AMENDMENT NO. 1 JULY 2016
TO
IS 12222 : 2011 AUTOMOTIVE VEHICLES — TURNING CIRCLE AND
MANEUVERABILITY REQUIREMENTS

(First Revision)

Amendment No. 1 to IS 12222 : 2011

FIG. 1 MANEUVERABILITY FOR RIGID VEHICLES

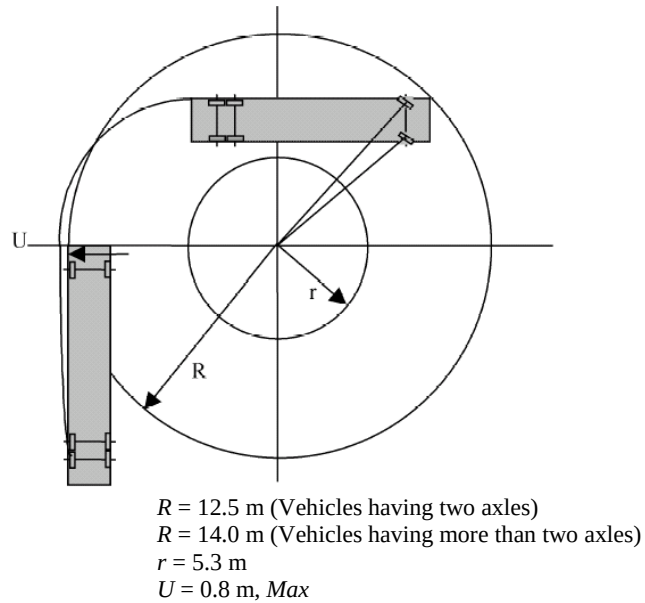
(Page 2, Fig. 1) — Substitute the following for the existing figure:

'5.1 The vehicle shall be able to maneuver on either lock inside a circle of radius R as shown in Fig. 1 or Fig. 2 as applicable without any of its outermost points projecting outside the circumference of the circle.'

'5.2 When the outermost points of the vehicle are moving on either wheel lock on a circle of radius R (see Fig. 1 and Fig. 2) the vehicle shall be able to move within the limits of circular track ($R-r$) wide as shown in Fig. 1 or Fig. 2 as applicable.'

FIG. 2 MANEUVERABILITY FOR ARTICULATED VEHICLES

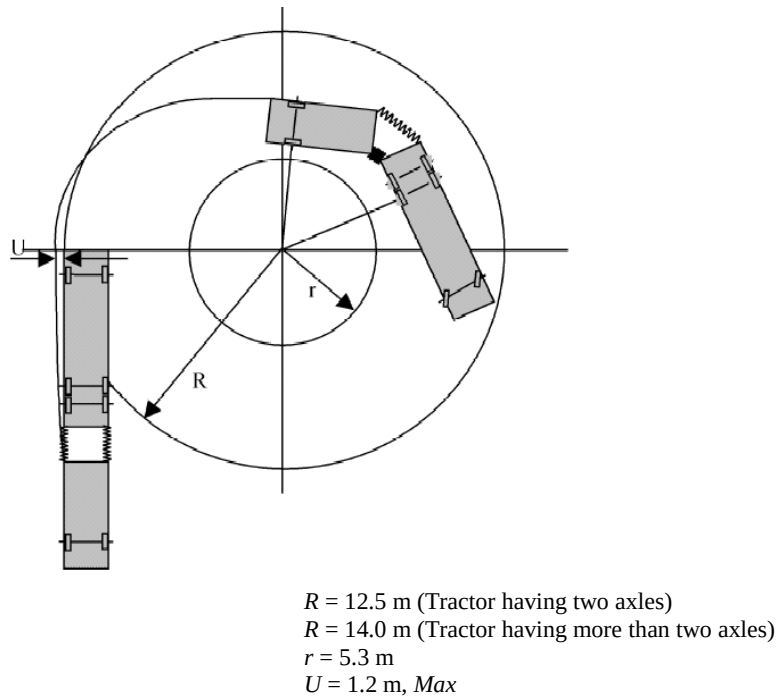
(Page 2, Fig. 2) — Substitute the following for the existing figure:
